RISO, INC. **PARTS CHANGE INFORMATION**

PART: STOPPER COLLAR; TM2400 **ISSUE #: 055**

NEW PART NUMBER: 13A5899 NEW DESCRIPTION: STOPPER COLLAR; TM2400 OLD PART NUMBER: OLD DESCRIPTION: "E" RING	[X] New [ ] Modified [ ] Obsolete [ ] Other
Compatible: [ ] Not Compatible: [ ] Old/Obsolete: [ ]

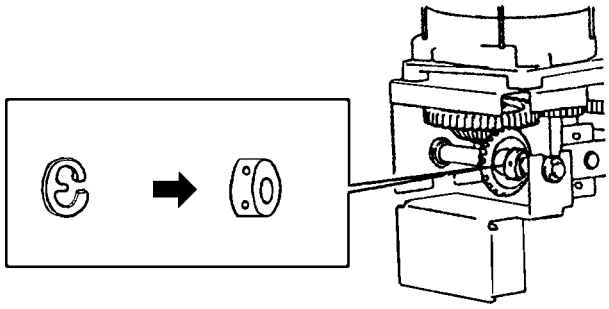
TO PREVENT THE BEVEL GEAR FROM DISENGAGING DURING OPERATION, THE SHAFT "E" RING CLASP IS BEING REPLACED WITH A STOPPER COLLAR THAT CAN BE SET IN A FIXED POSITION ON THE SHAFT.

THIS NEW PART IS MADE AVAILABLE THROUGH CUSTOMER SERVICE BY ORDERING:

PART NUMBER: 011-18796 STOPPER COLLAR;TM2400
